Date: November 10, 2022
To: Planning Board
From: Camille Pattison, NRPC Assistant Director
Subject: SP2022-08 Sooner Transportation LLC, for the property located at Tax Map 12, Lot 11, 754-756 Elm Street (Horseless Carriage Site). Public Hearing for a Major Site Plan Application to construct a two-story, 10,320 sf. auto sales and repair facility with associated parking, stormwater management/drainage, landscaping, and lighting improvements on the subject property located in the Commercial ‘C’ Zoning District and West Elm Overlay District.

Attached, please find a revised submittal package, including the Elm Street Gateway District justification, revised waiver requests, revised site plan (revision date 11/2/22) and updated building concept, from the applicant’s engineer, Bedford Design Consultants.

**Re: Sooner Milford Site Plan (Tax Map 12, Lot 11) – 754 and 756 Elm Street
Site Plan Drainage Review**

FRONT ELEVATION / PIT CREW T&O :: **A**
 scale: 3/32"=1'
 3
 REVISED

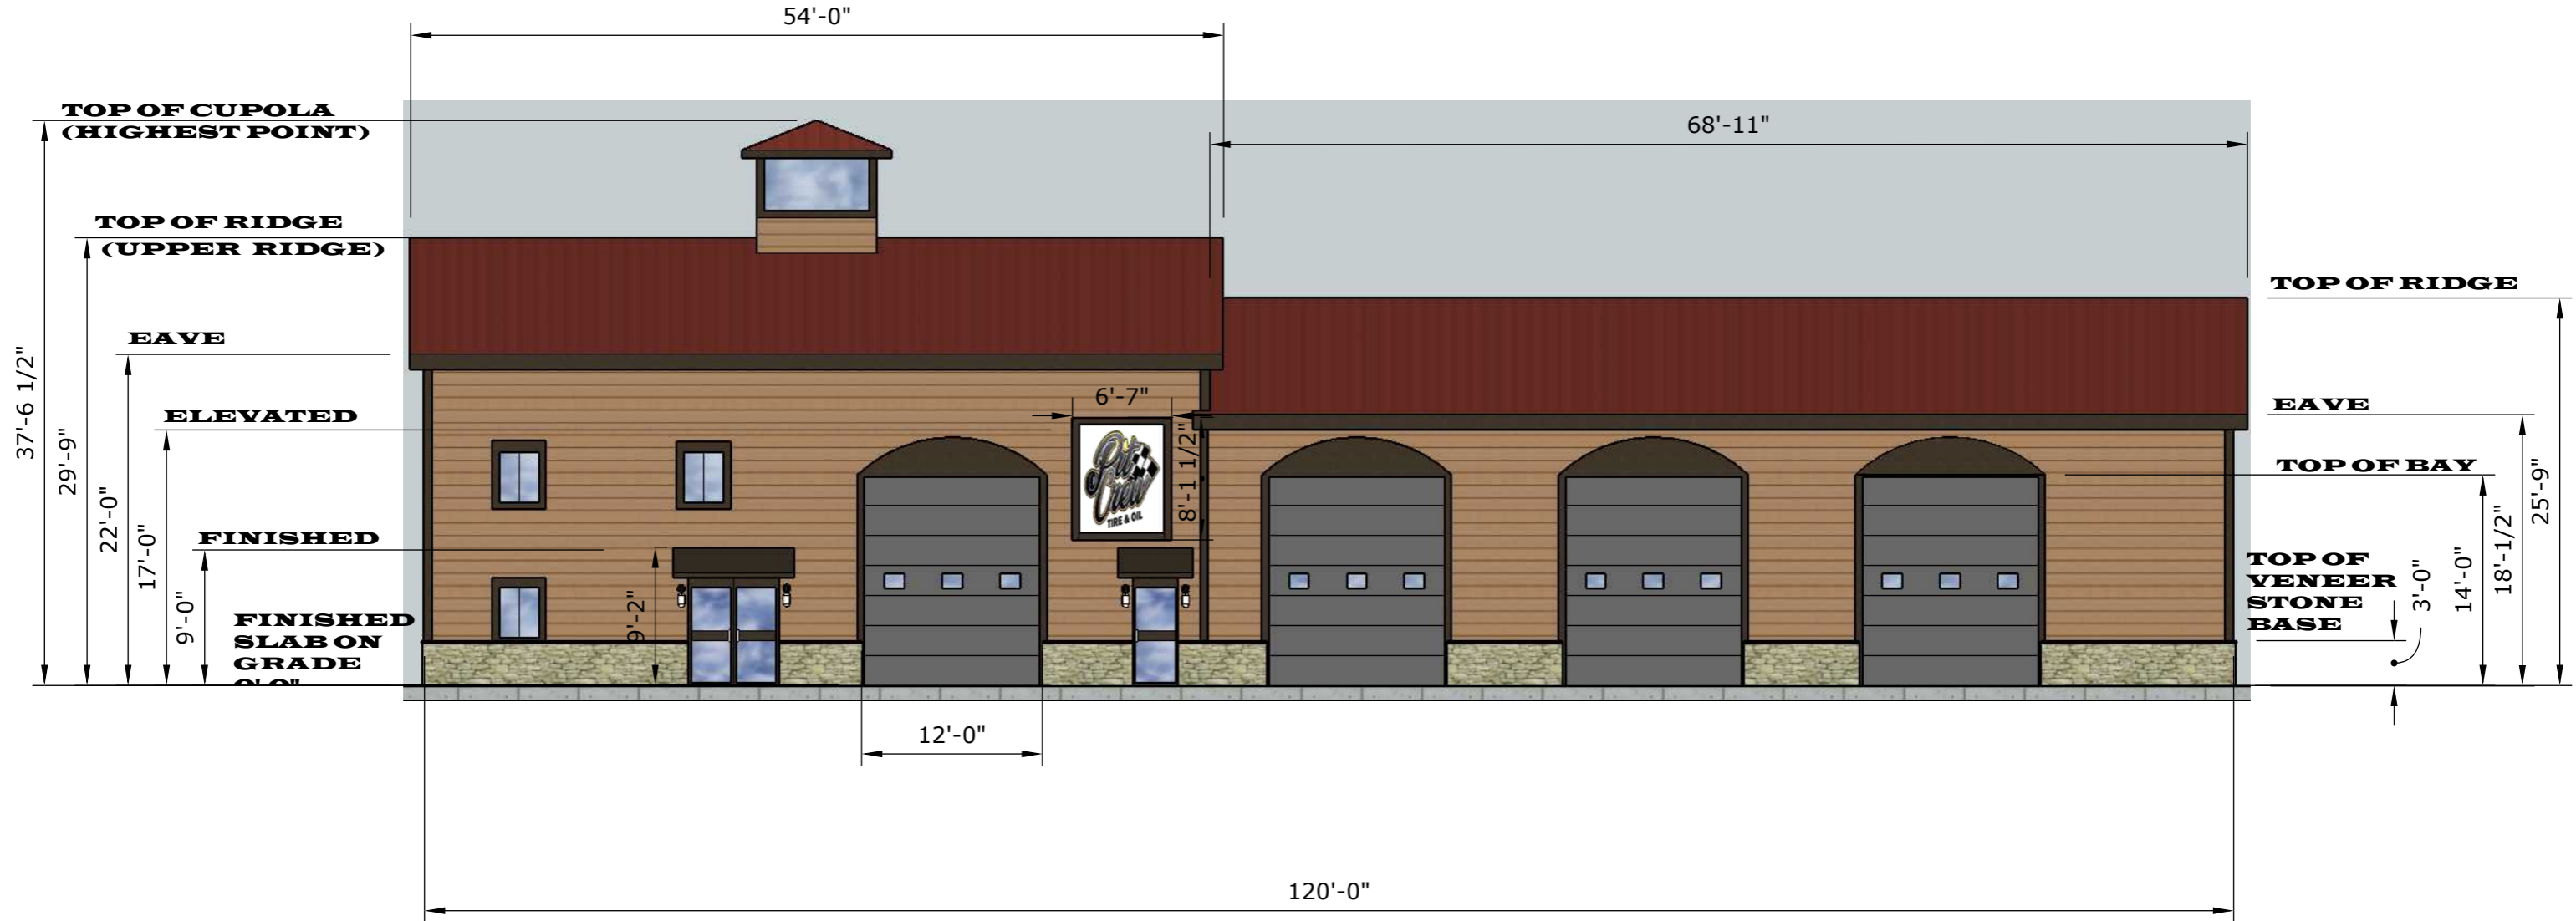
16. Sheets 1 and 6 - Pursuant to the Zoning Ordinance, Section 6.07.6.E.2.b, the proposed building should enhance the definition of each floor of the building through terracing, material changes, articulated structural elements, changes in materials and horizontal trim bands. The applicant should explain how the proposed building complies with this section. ***Revised Architectural Plans Submitted on 11/3/22.***

17. Sheets 1 and 6 – Please explain how the proposed building architectural features and materials comply with the Zoning Ordinance, Section 6.07.6.E.3. ***Revised Architectural Plans Submitted on 11/3/22.***

18. Sheets 1 and 6 – Pursuant to the Zoning Ordinance, Section 6.07.6.E.4.a, the proposed building design should avoid blank walls at ground-floor levels through the use of windows, trellises, material changes, arcades, or other features to increase visual interest. The applicant should be prepared to discuss how the proposed building complies with the section. ***Revised Architectural Plans Submitted on 11/3/22.***
